MS 10945

.051 THICK		STOCK SIZE		TMC (Canada) LIMITED	
ALUM. ALLOY		WEIGHT PER PC		OTTAWA ONTARIO	
MATERIAL		TYPE & TEMPER		COVER	
57S-H34				TOP & BOTTOM	
DRAWN		ELEC. DES. APP.		MECH. DES. APP.	
CHECKED		FINAL APPROVAL		MS 10945

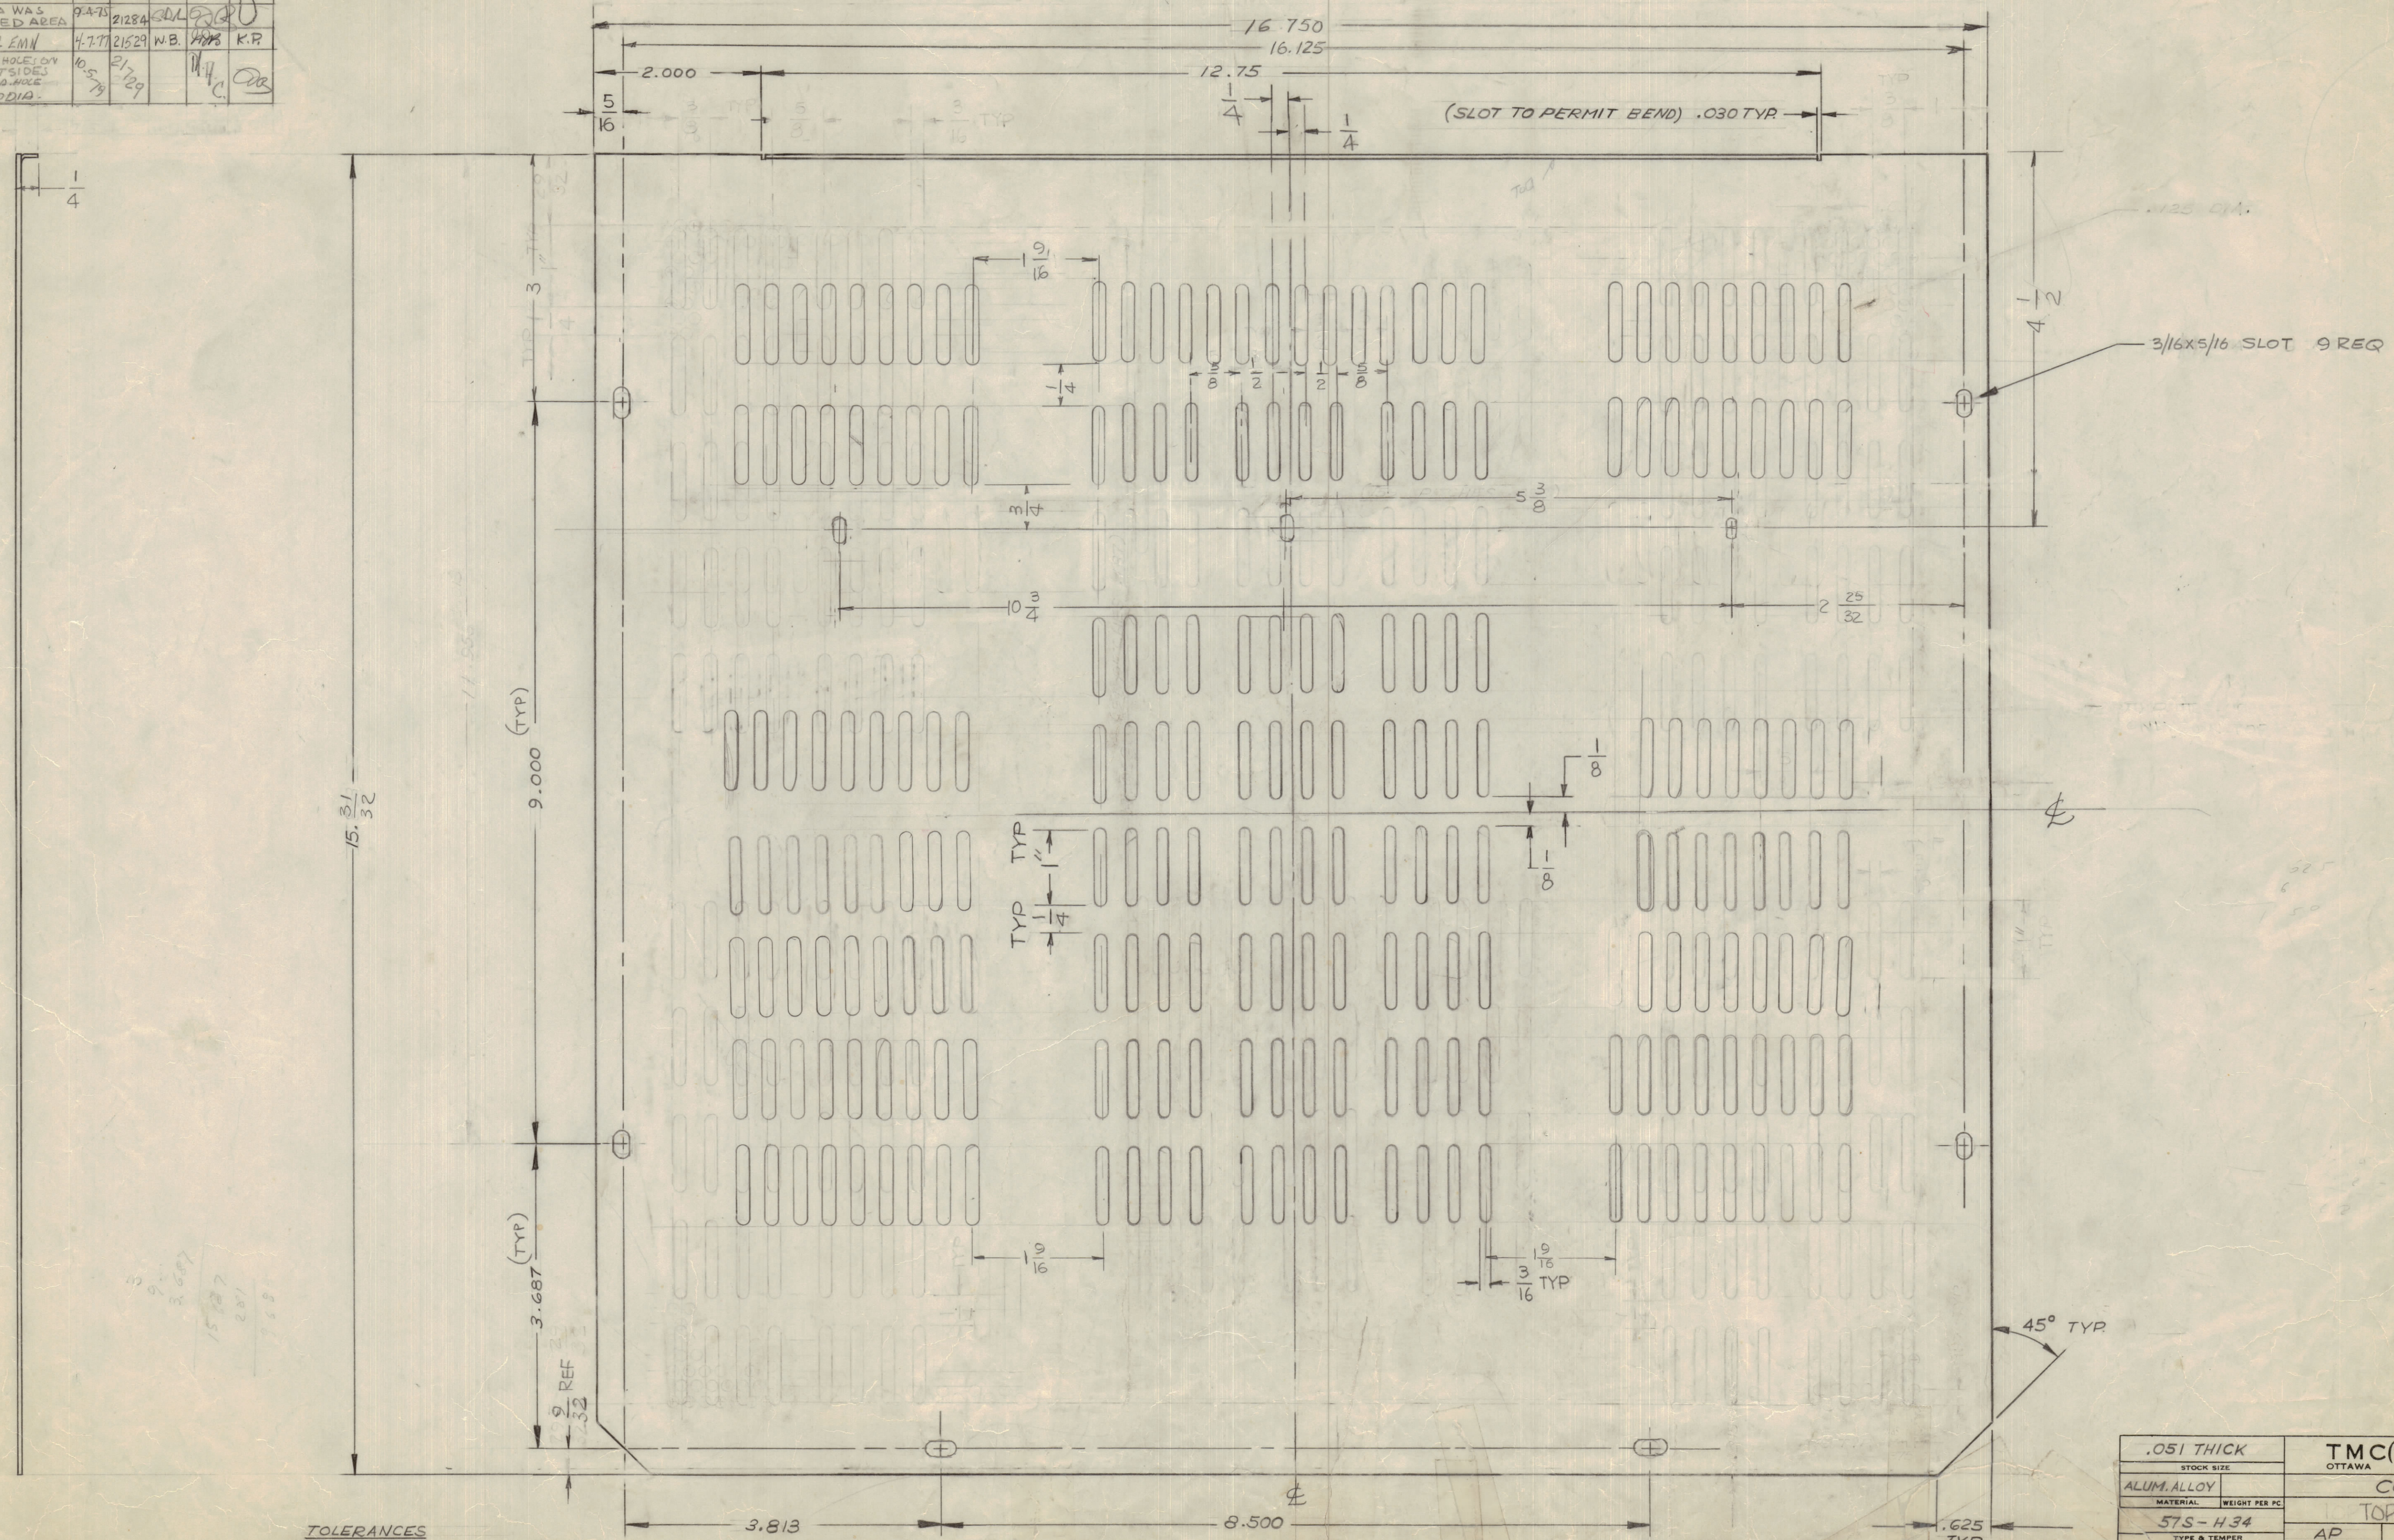
IF IT IS FOUND DESIRABLE TO CHANGE ANY TOLERANCE OR OTHER DETAIL SPECIFIED ON THIS DRAWING NOTIFY THE PURCHASER PROMPTLY.				
MAXIMUM ALLOWABLE TOLERANCES HAVE BEEN DETERMINED AND DEVIATIONS WILL BE CAUSE FOR REJECTION. REMOVE ALL BURRS AND SHARP EDGES.				
ISSUE	ITEM	CHANGED FROM	DATE	CN. NO.
0		REL. TO PROD.	APR 7, 69	
A		SLOTS AREA WAS PERFORATED AREA	9-2-73	21284
B		REVISED PER EMN	4-7-77	21529
C		ROUND SLOTS HOLE LON LEFT & RIGHT SIDES DELETED. DIA. HOLE 3/16 WAS .250 DIA.	10-5-79	21729

D	DIM 11.953 DELETED, DIM 1/2 WAS 3/8	5-14-80	21803	RU
E	6 slots were 3/16 DIA. DIM 3/16 WAS 1/4			
F	DIM 15 31/32 WAS 15.859	2-14-99		COL
G	TWO SLOT HOLES ADD	11-1-99		COL
	FOUR ROW SLOT ADD ON TOP COVER	11-5-99		COL
